**PZ&B Staff Combination Memorandum: Landmarks Preservation Commission and Town Council**

**SUBJECT:** ZON-22-121 (HSB-22-012) 428 CHILEAN AVE (COMBO)

**HSB-22-012 (ZON-22-121) 428 CHILEAN AVE—FLOODPLAIN VARIANCE (COMBO).**

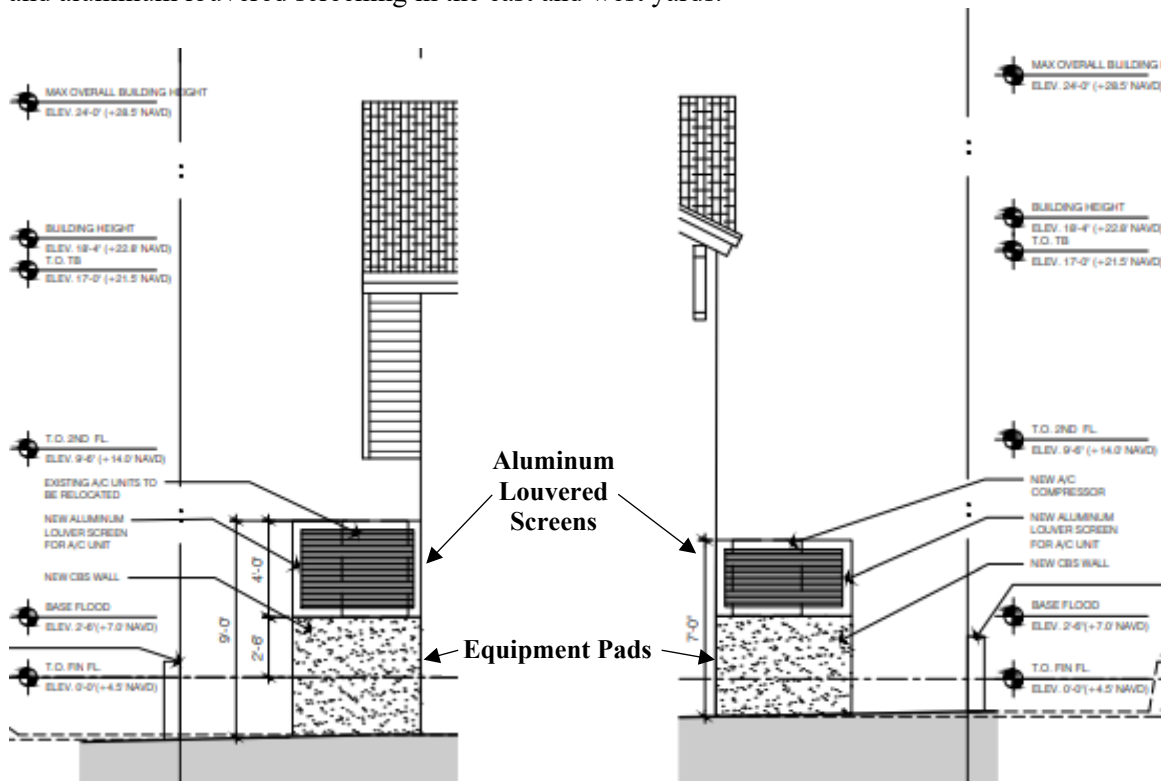
As it pertains to **Variance #1**, the application seeks to substantially improve and expand the existing residence, which has a non-compliant finished floor of 4.5' NAVD, whereas the current requirement within the AE6 flood zone is 7' NAVD. A flood plain variance is being requested for

the historic structure to allow an addition with a finished floor of 4.5' (lowest slab of interior habitable space) in lieu of the 7 ft required by code. As such, a flood plain variance is necessary for construction at 4.5' NAVD. The floodplain waiver is only afforded to Landmarked and Historically Significant Buildings and is one of the greatest benefits of the program for older, currently non-compliant historic building stock. Final authority of the flood plain variance is with the Landmarks Preservation Commission.
